Office Action Summary

10/784,193

OKUI, YOSHIAKI

DETAILED ACTION

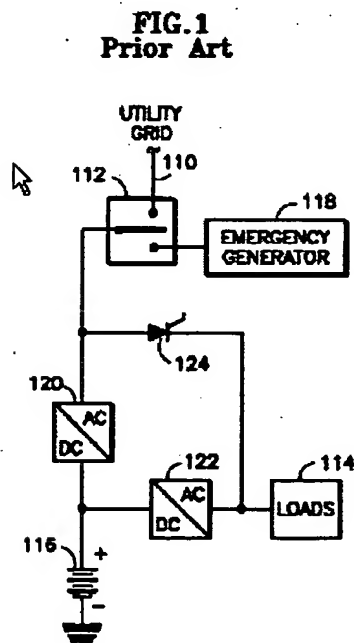
JP discloses in figures 1-3 and abstract a control circuit CPU and a judgment circuit judges the degradation of the storage battery based on a charging time of the storage battery.

SOLUTION: Using a clock IC 3 backed up by a primary battery 5 and a first memory 2, a clock data at power-on stored in a first memory 2 is compared with a clock data stored lastly before power-on to determine the power-off elapse time of a device. The clock data at power-on is compared with a clock data stored at a prescribed cycle after power-on to determine the power-on elapse time of a device. Based on the power-off elapse time and power-on elapse time determined respectively, the discharging time and charging time of a secondary battery 9 are controlled. It is thus possible to reduce the performance degradation of the secondary battery 9 and estimate the service life of the secondary battery 9 in step with charging and discharging cycle.

PROBLEM TO BE SOLVED: [To reduce the performance degradation of a secondary battery by controlling the discharging time and charging time of the secondary battery based on power-off elapse time and power-on elapse time.
